# COMMUNITY DEVELOPMENT DEPARTMENT REPORT

HEARING DATE: 9/3/2026

APPLICANT: Daphne Romani

SUBJECT: H-2026-0048  
Black Creek Legal Office

### B. Site Plan (date: 6/24/2026)

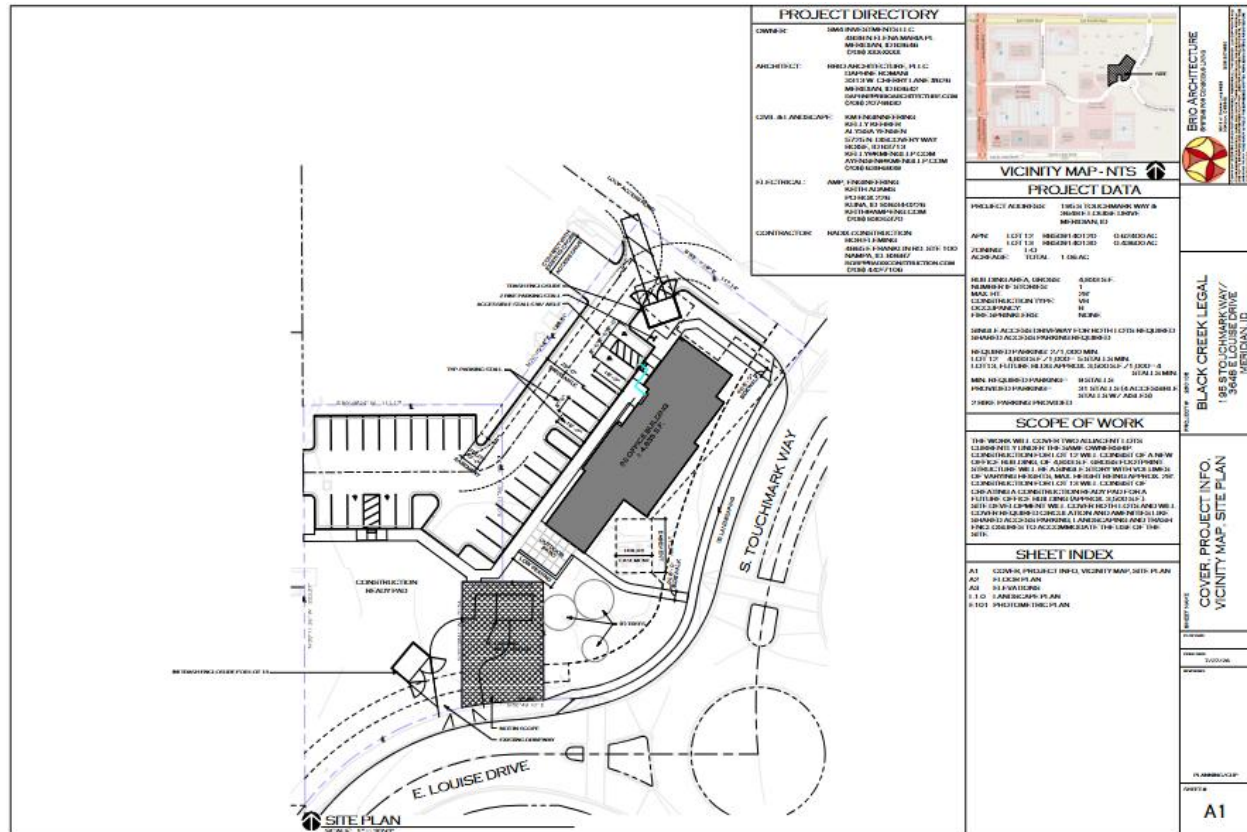
1. There is an existing stub located at the SW corner of the site. Water meter needs to connect within 3' from end of stub. Callout removal of the Blow-off. Water meters need to be located in a landscaping area.

2. Water services require a 20' easement up to the water meter. The city request that the easement extends 10' past the water meter but only 5' is required.

4. Carports and other permanent structures (trees, bushes, buildings, trash receptacle walls, fences, infiltration trenches, light poles, etc.) cannot be built within the utility Easement.

5. Ensure no Sewer services cross infiltration trenches. Sewer service lines through underground seepage beds or swales are not allowed unless approved by the City Engineer.

2. The site plan and/or landscape plan, as applicable, shall be revised with the certificate of zoning compliance application as follows:
  - Address Public Works comments regarding easements.
